**RE: Technical Revision 3 Adequacy Review 1 – Monarch DENM Mine (Permit M-2022-009), Weld County, Colorado**

MONARCH-DENM GRAVEL MINE  
DRMS 112 PERMIT APPLICATION  
WELD COUNTY, COLORADO

RECLAMATION  
PLAN  
MAP

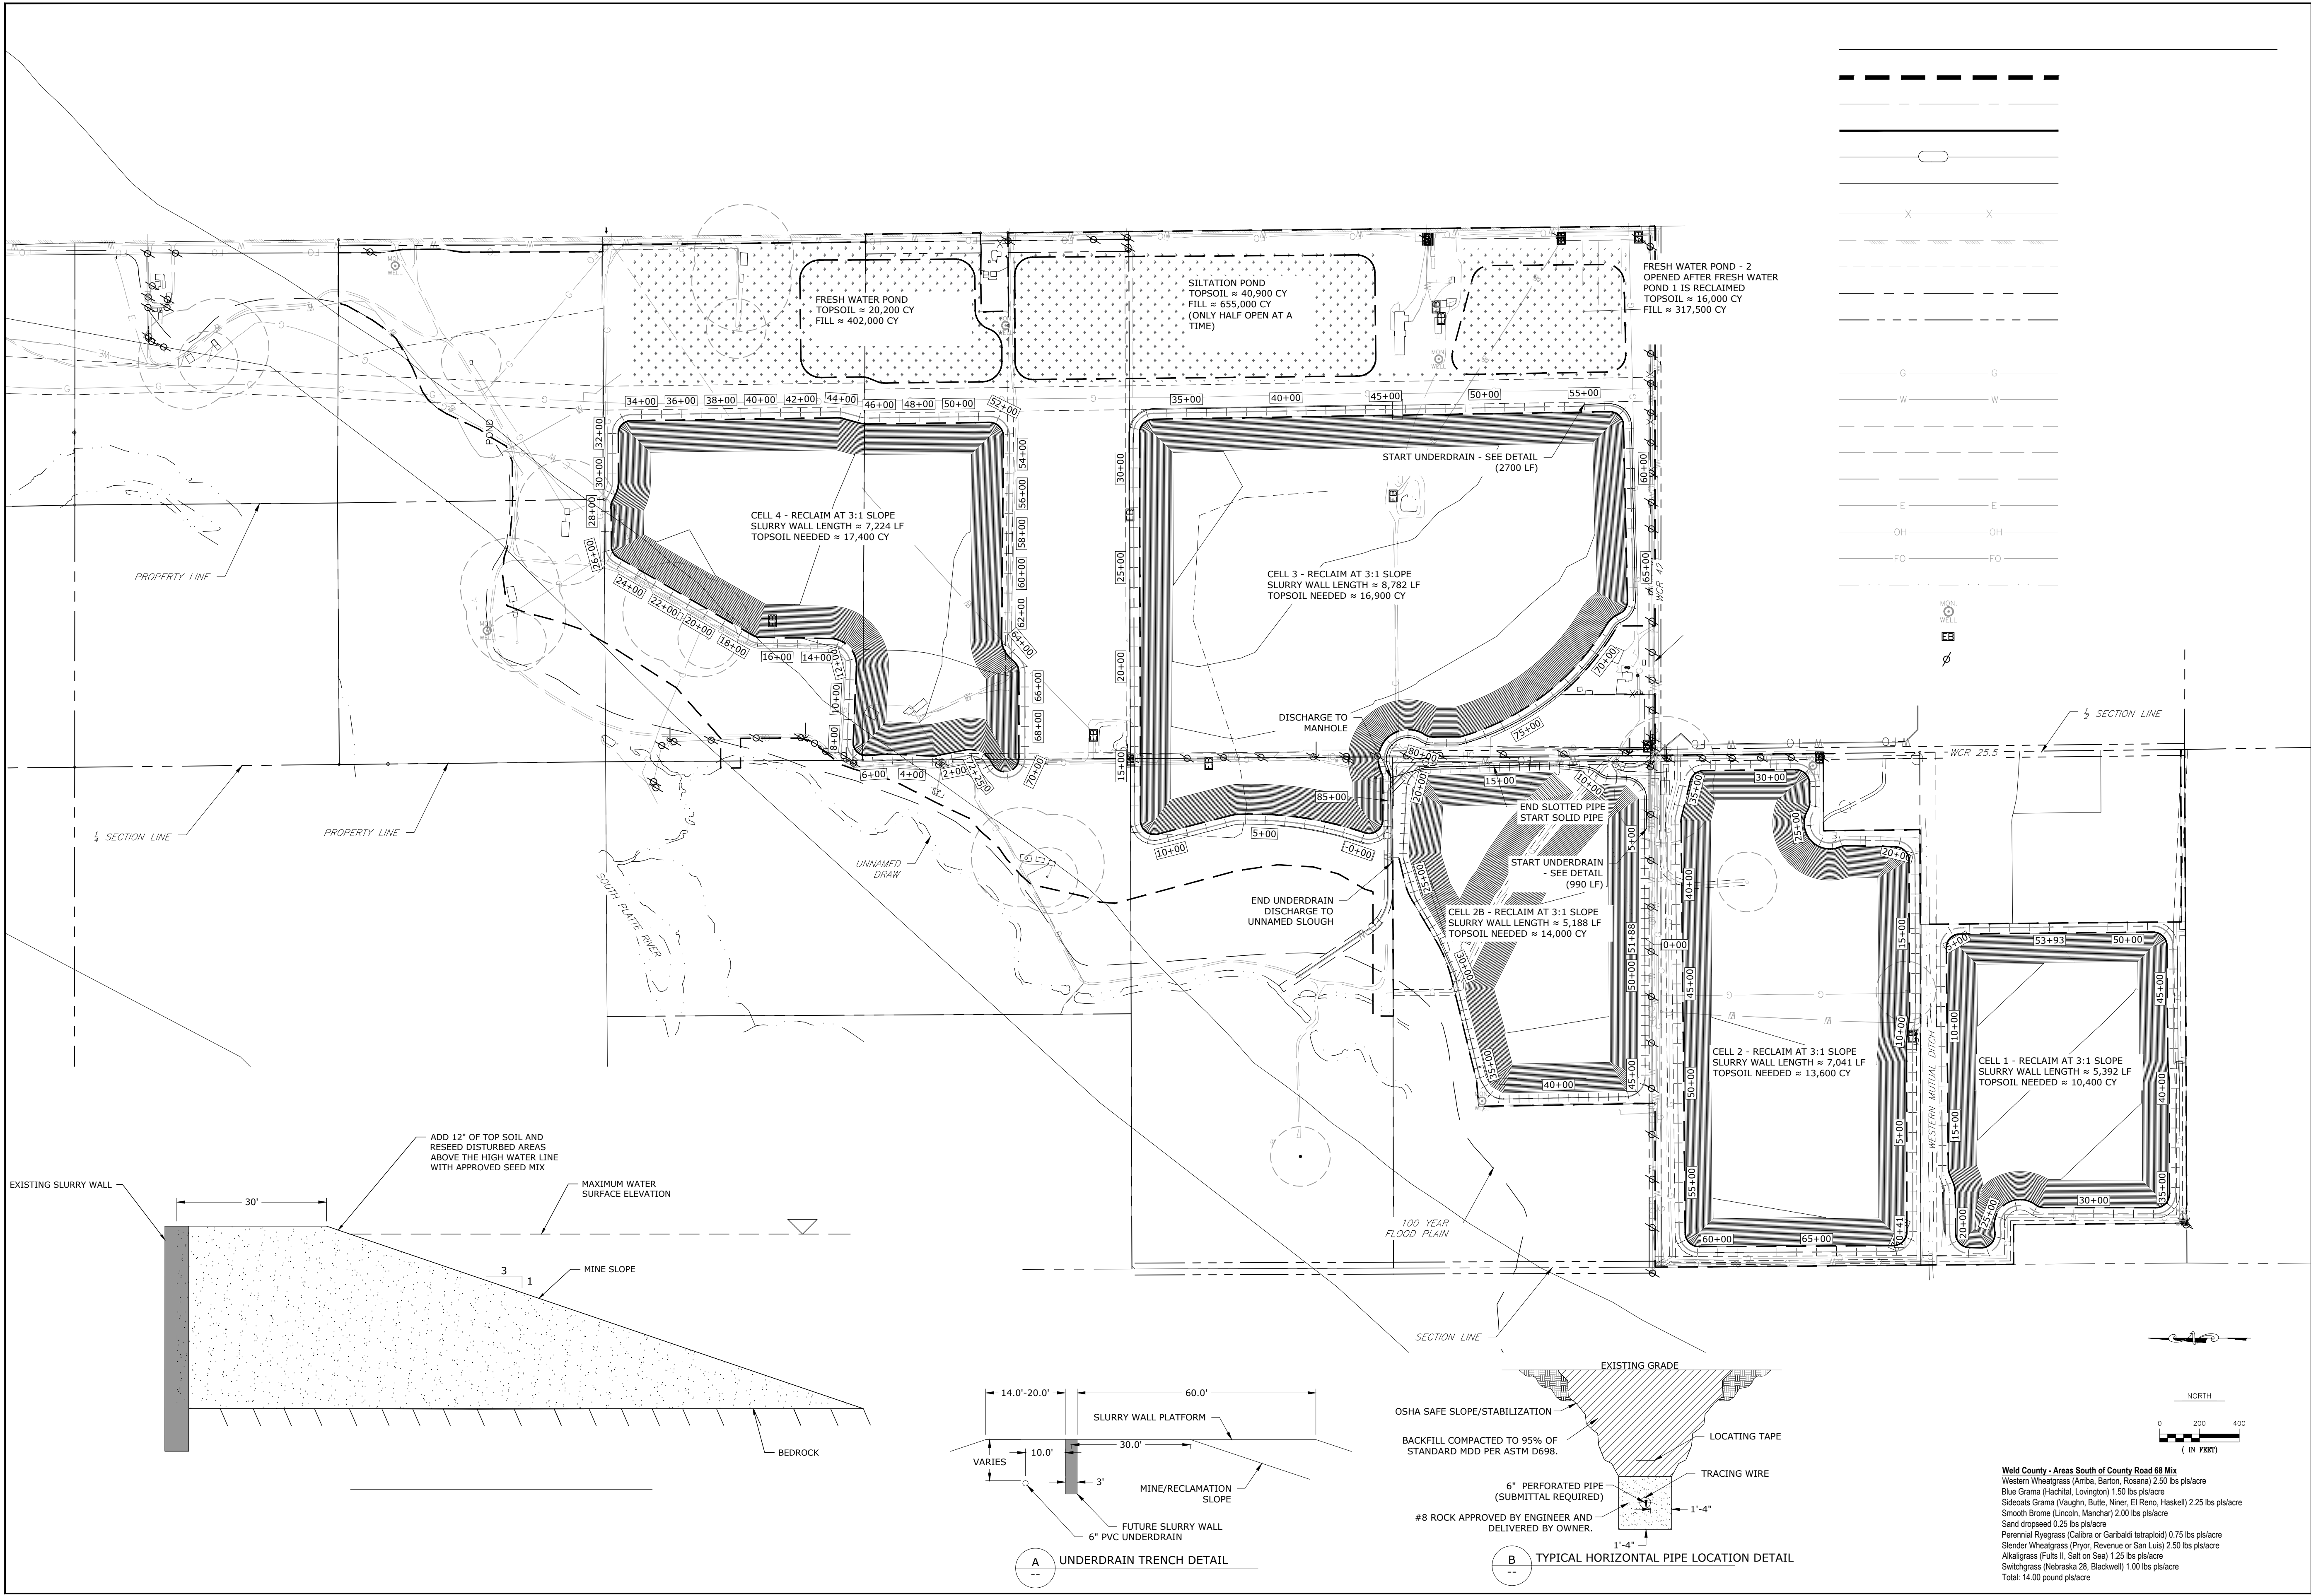
*1. In TR-3 it is stated that the Cell 4 slurry wall curtain area is approximately 397,320 square feet (sq ft). In TR-2 the Cell 4 slurry wall curtain area was to decrease to 386,980 sq ft due to a reduction in overall length from 9,042 feet to 7,036 feet with the oil and gas infrastructure that was to be installed between Cells 3 and 4. Please clarify the discrepancy and provide an updated Reclamation Plan Map to show just the currently approved cells with their associated slurry wall length, and the location and length of all approved underdrains.*

**The slurry wall curtain area should be updated to 397,320 square feet, in the previous TR the length of the mine limit was mistakenly used. An updated Reclamation Plan Map has been included to show the currently approved cells with their associated slurry wall lengths and underdrains.**
